HISTORIC AND DESIGN REVIEW COMMISSION

April 06, 2022

HDRC CASE NO: 2022-145
ADDRESS: 922 NOLAN ST
LEGAL DESCRIPTION: NCB 1666 BLK J LOT 7
ZONING: R-5, H
CITY COUNCIL DIST.: 2
DISTRICT: Dignowity Hill Historic District
APPLICANT: Juan Osorio /OSORIO PROPERTIES LLC
OWNER: Juan Osorio /OSORIO PROPERTIES LLC
TYPE OF WORK: Fencing, fenestration modifications, amendment to a previously approved design, porch modifications
APPLICATION RECEIVED: February 25, 2022
60-DAY REVIEW: Not applicable due to City Council Emergency Orders
CASE MANAGER: Edward Hall

ROOF PLAN

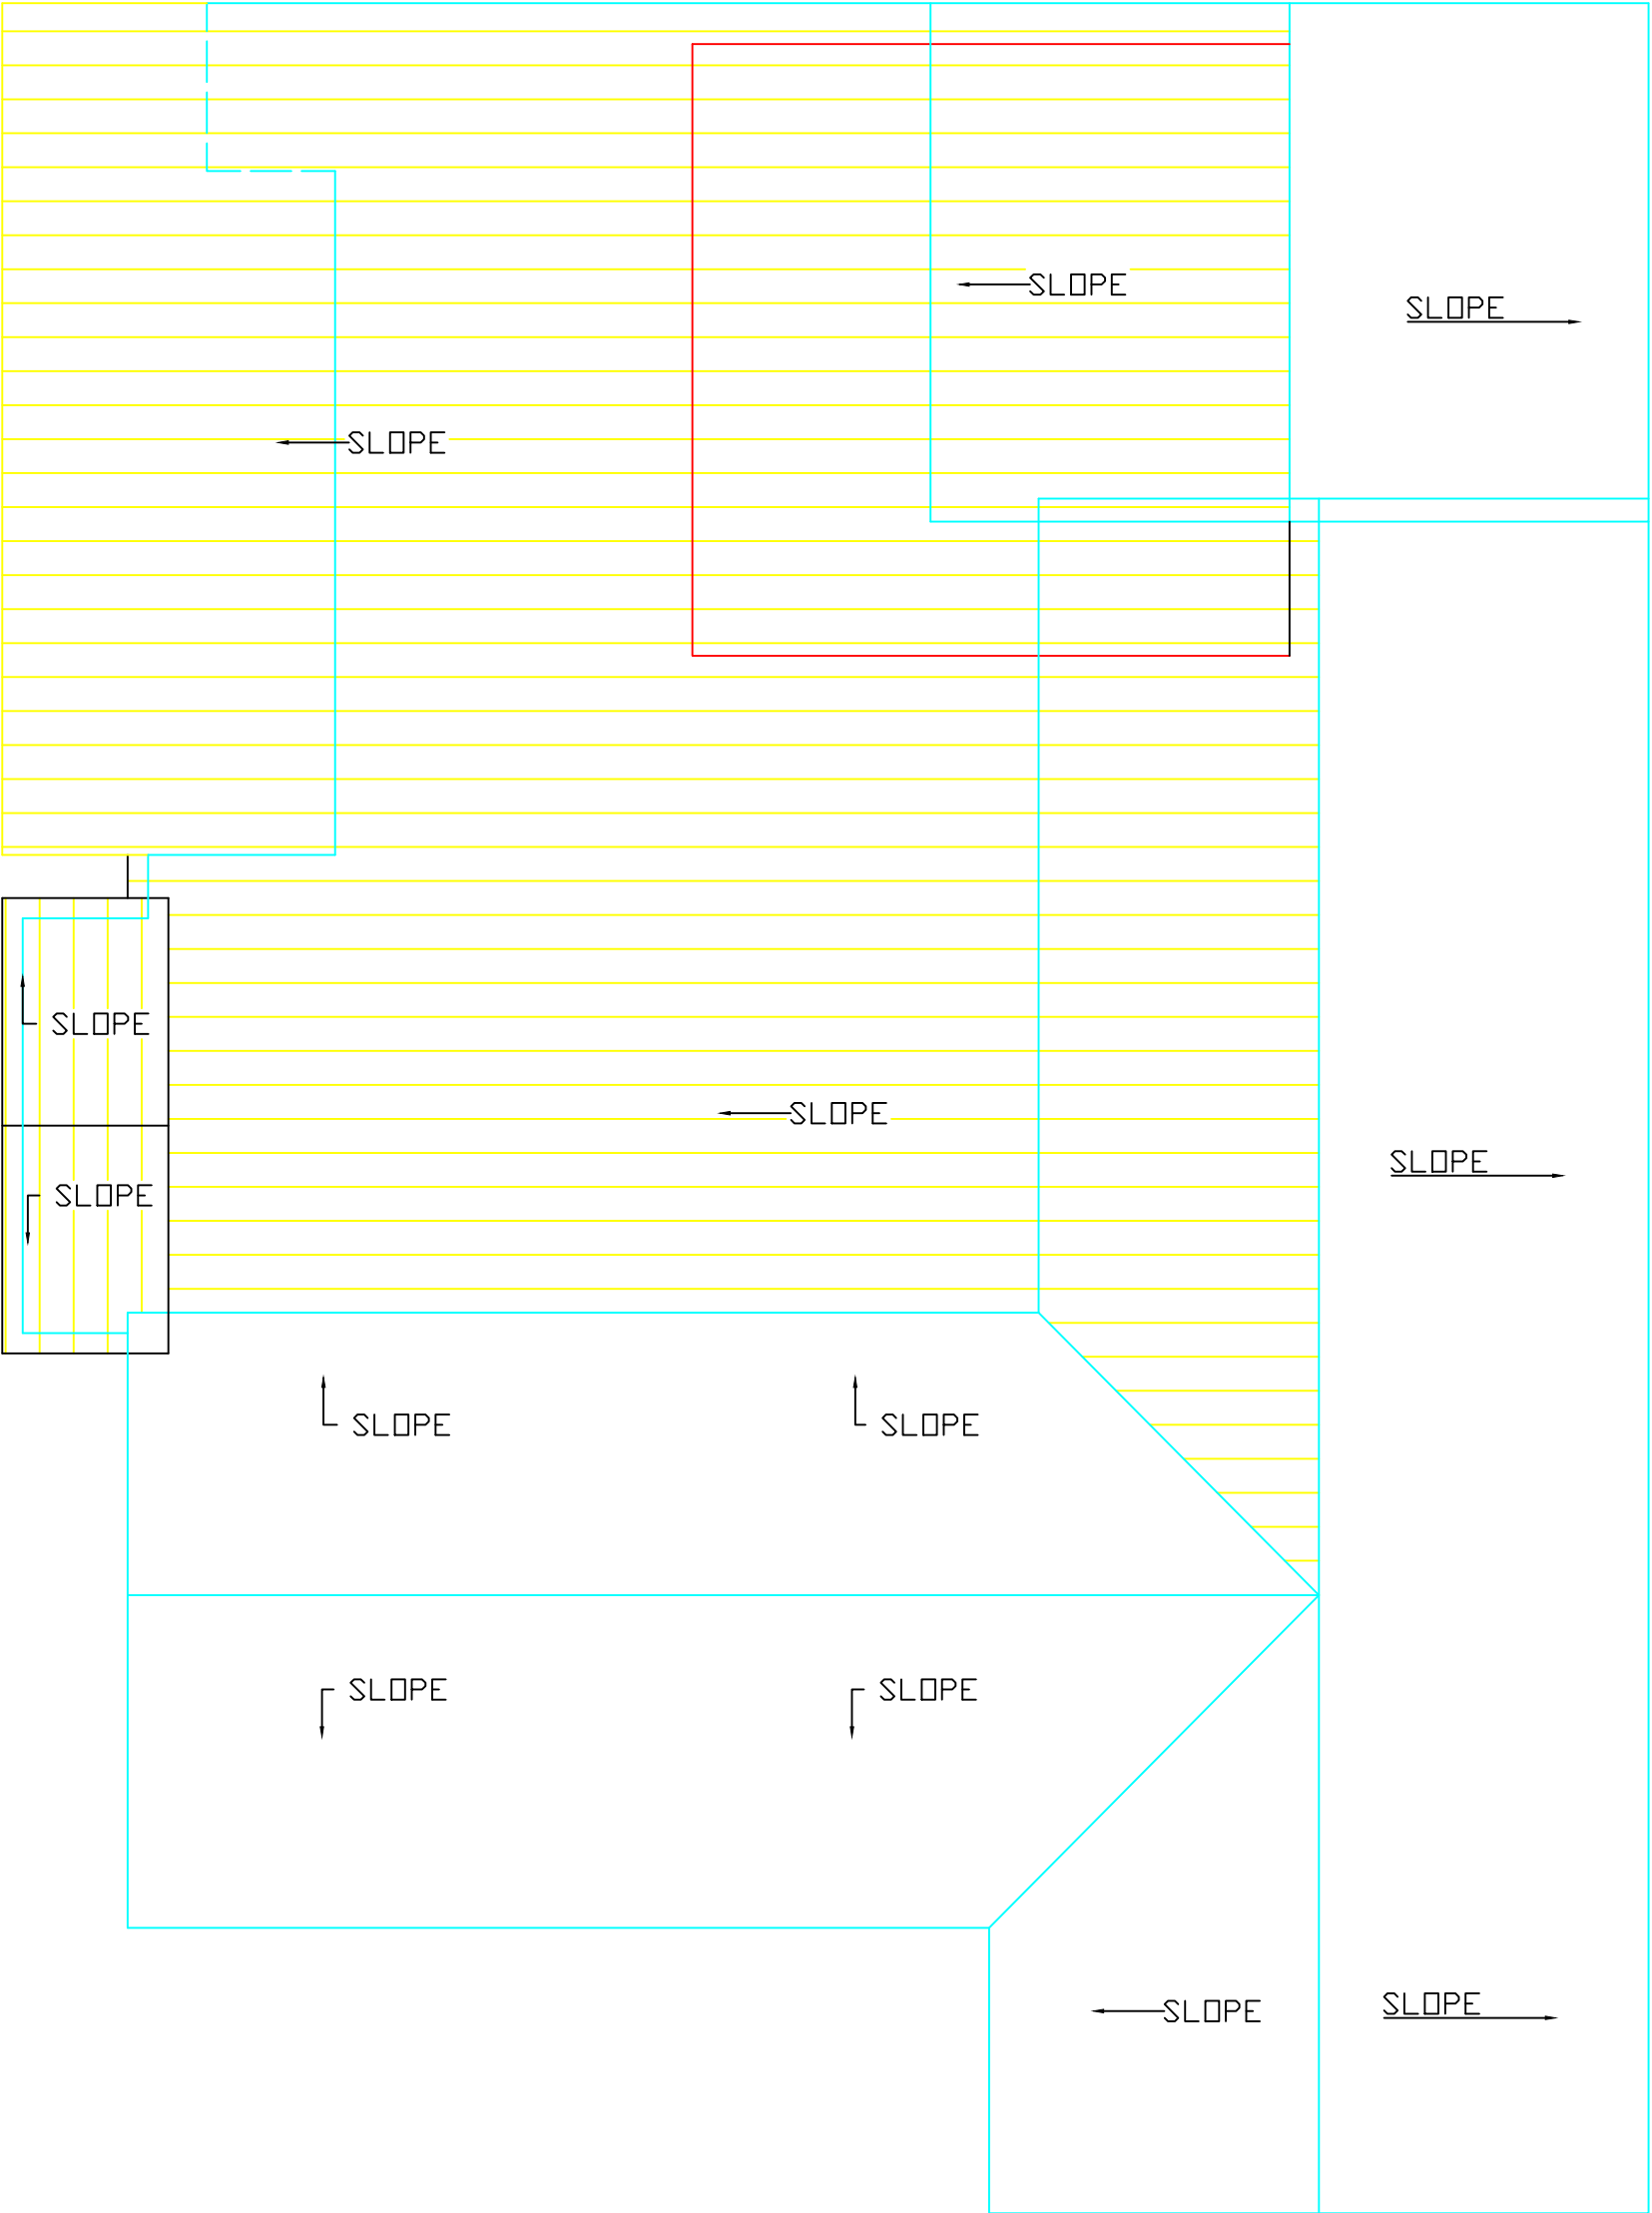
- k. ADDITION/ROOF MODIFICATION – The applicant has proposed to construct a rear addition that features profile modifications to the original roof form and modified fenestration profiles. At the September 2, 2022, HDRC hearing, OHP staff did not recommend approval of the proposed roof form as it featured a contemporary roof form. Staff recommends that the applicant propose a gabled roof form, consistent with the Guidelines. The commission approved the modification with the stipulation that the final construction documents be reviewed by OHP staff to ensure consistency with the OHP's recommendation. Staff finds the construction roof form to be inconsistent with the Guidelines.

8. Staff does not recommend approval of item #8, the construction of a rear addition with a shed roof form. Staff recommends the applicant install a gable roof. Staff finds the modified fenestration profile of the addition to be appropriate.
